OFFICIAL STAR CLASS MEASUREMENT CERTIFICATE**Sec. A. DESCRIPTION OF MEASURED YACHT**

1. YACHT'S NUMBER? 4749
2. Was this number cut or burned into keelson as required above? yes
3. Yacht's name "CONQUERER" 4. Year built 1963
5. By whom built? Eichenlaub Yacht & Marine Service, San Diego, Calif.
6. Owner's Name: Malin Burnham
7. Address: 535 San Geronimo, San Diego, California
8. Fleet SDB

October 17, 1964

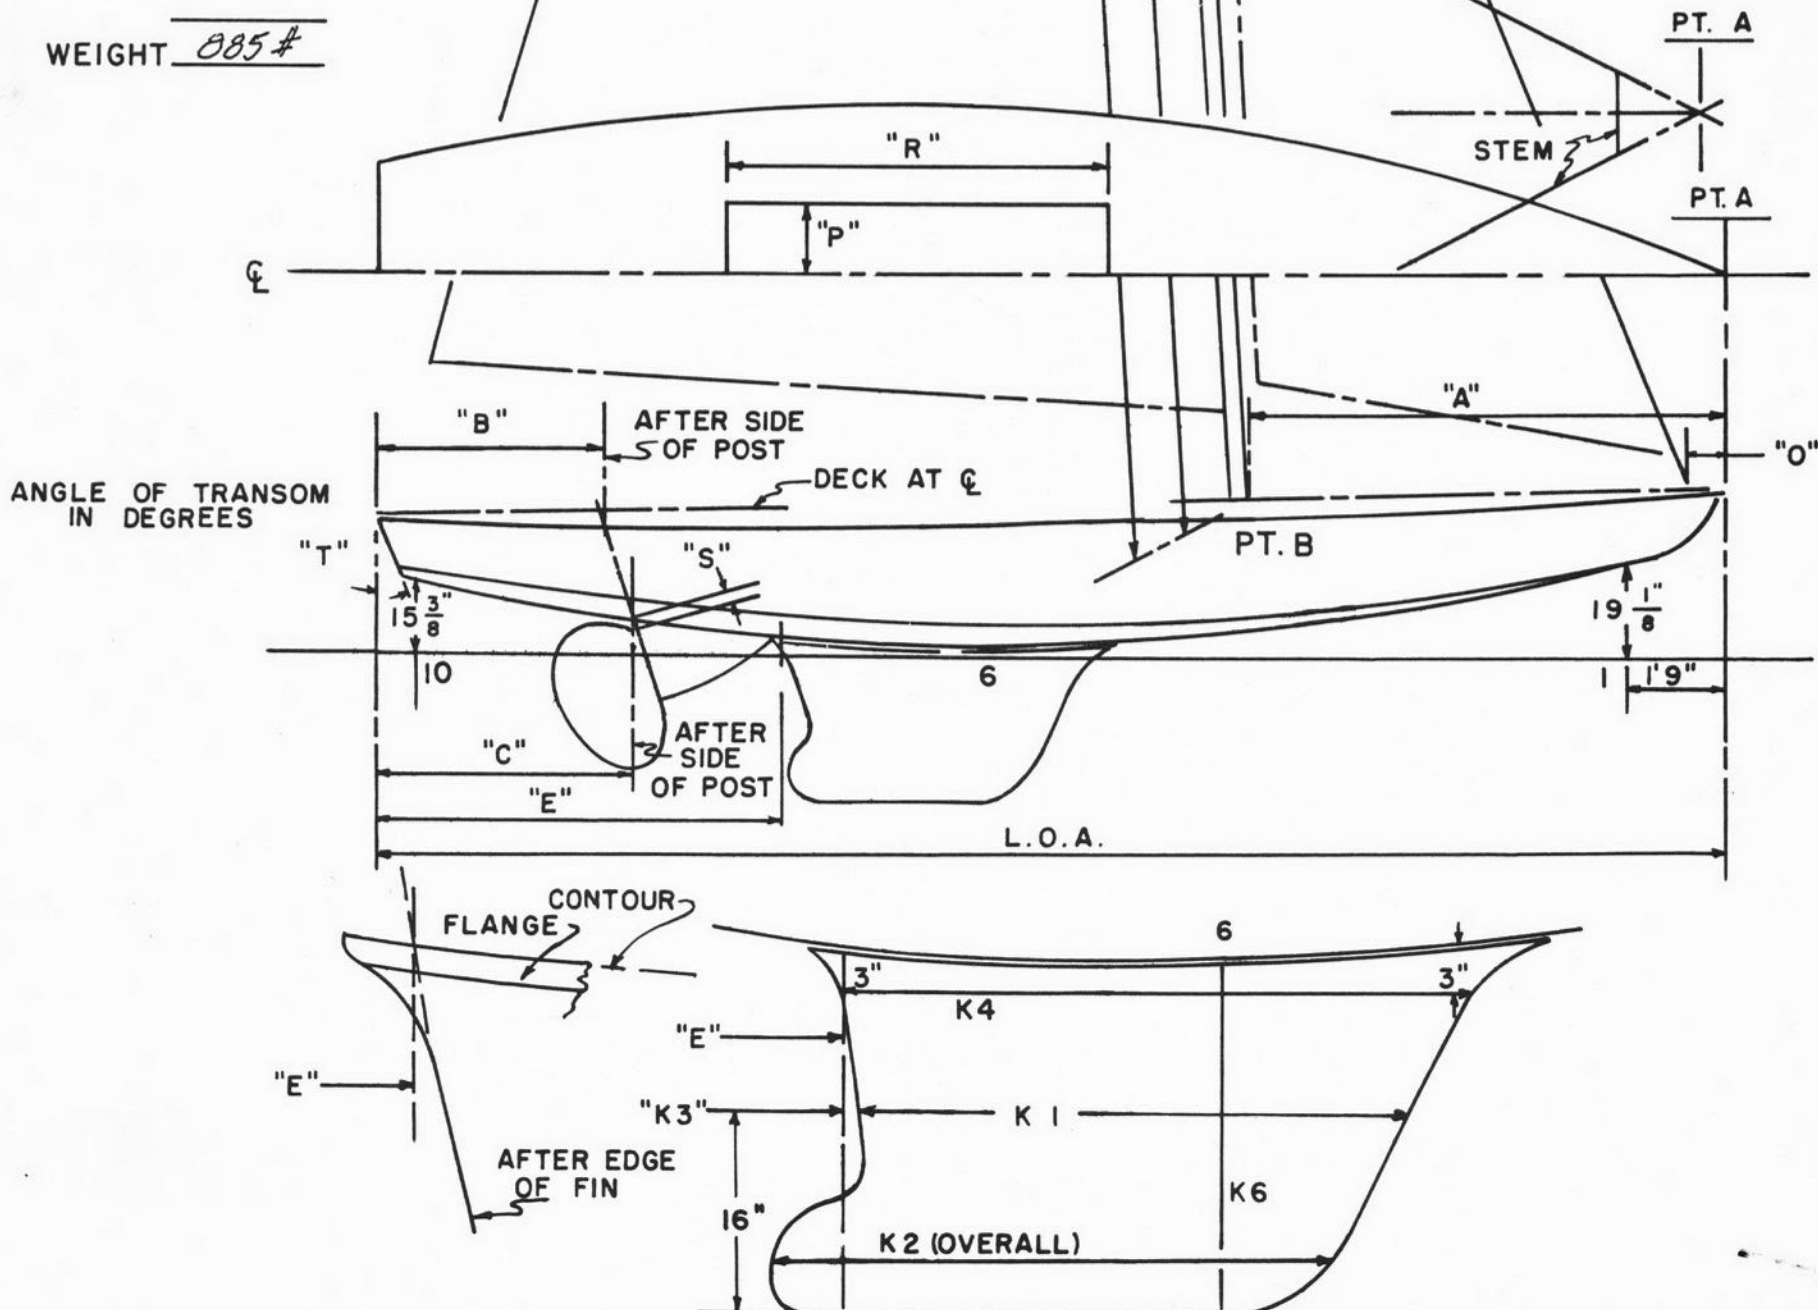
As you know, Star No. 4749 was carefully measured by A. W. Daniels at the request of the Measurement Committee and Governing Committee, and there are still some deviations from design which must be corrected.

You should bring the shape of the bottom of your boat to a true arc from Station 9 aft. If this requires shaving on the outside, appropriate battens should be glued to the inside to bring the hull to required thickness. In addition, it appears that your faring in the way of the keel is too wide. This is a common mistake arising from a misreading of the Specifications. Article XV provides that faring strips may not be more than 12" from outboard edge on one side to outboard edge on the other, but many people have misinterpreted that in careless fashion to mean that the faring strip may not be more than 6" from the edge of the keel.

It is requested that you have this corrective action taken as to bottom shape and faring strips on or before December 31, 1964, and report to me by that time so that steps may be taken to insure that your certificate will be reinstated and in good standing.
